**OHIO TURNPIKE AND  
INFRASTRUCTURE COMMISSION**

**ADDENDUM NO. 3**

**PROJECT NO. 43-19-06**

BRIDGE REHABILITATION AND 3RD LANE WIDENING M.P. 237.17 TO M.P. 238.63  
OHIO TURNPIKE OVER POLAND-UNITY ROAD M.P. 237.8, OHIO TURNPIKE OVER  
COLUMBIANA-NEW CASTLE ROAD M.P. 238.1  
MAHONING COUNTY, OHIO

**GENERAL SUMMARY**

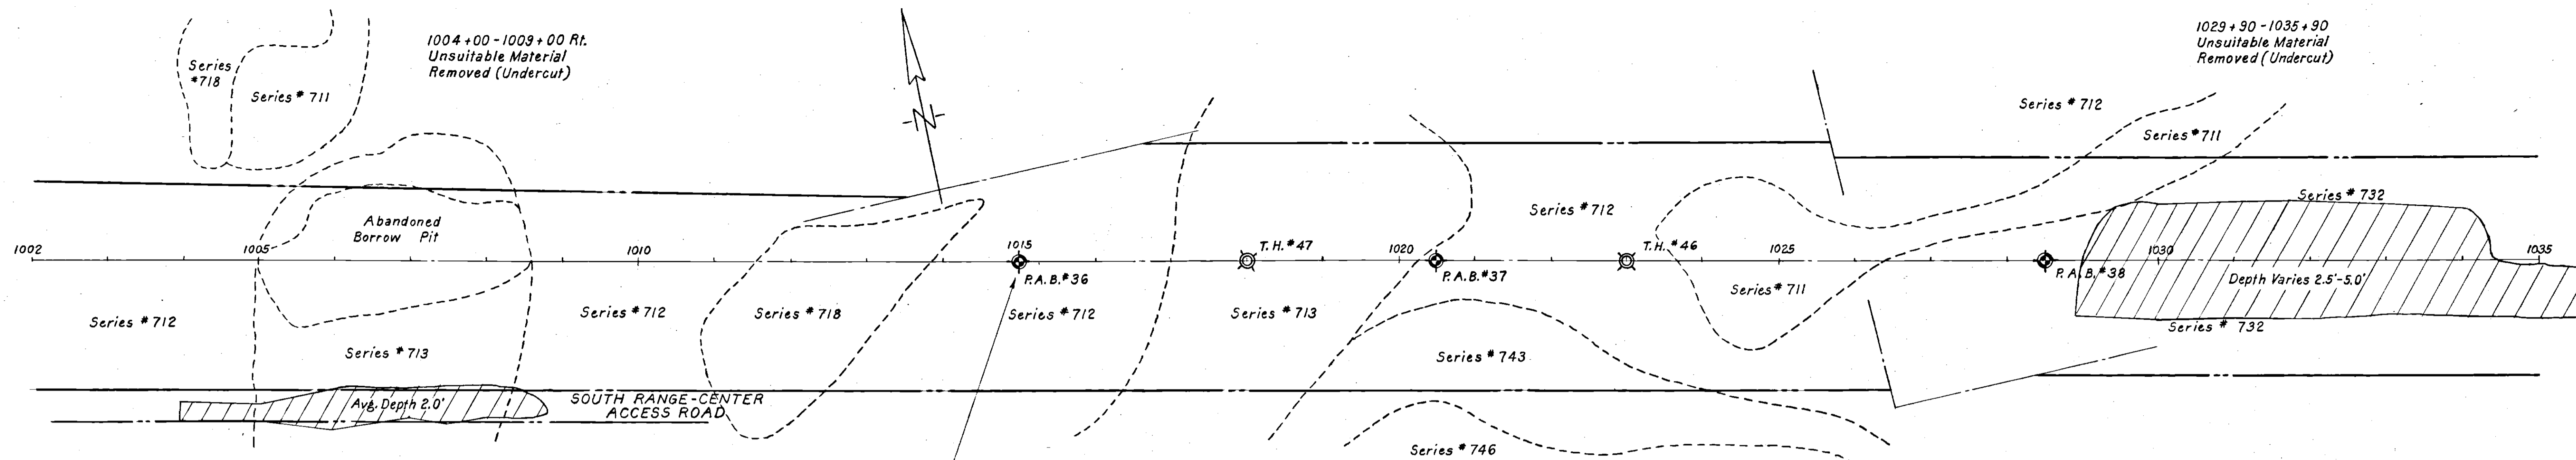
*A#13 The note should have read “shall consist of the removal and replacement of the full depth of all slag material courses encountered within the limits of the cement stabilization areas...”. The plan note, including quantities, on Plan Sheet 11 of 186 have been revised, and the respective quantities on Plan Sheet 14 of 186 have been revised through this Addendum 3. The Bid Schedule of Items for Reference Nos. 10 and 11 are revised through this Addendum No. 3. The revised Plan Sheets 11 and 14 of 186 are included as part of this Addendum No. 3.*

*A#14 Please see response to Q13. The Excavation, As Per Plan, and Embankment quantities have been revised as noted in the response to Q13 through this Addendum No. 3.*

THIS ITEM SHALL CONSIST OF THE REMOVAL AND REPLACEMENT OF THE FULL DEPTH OF ALL SLAG MATERIAL COURSES ENCOUNTERED WITHIN THE LIMITS OF CEMENT STABILIZATION WITH MATERIAL CONFORMING TO 203.02. FILL MATERIAL SHALL CONFORM TO 203.02 AND BE PLACED ACCORDING TO 203.06.

10,500 CY  
10,500 CY
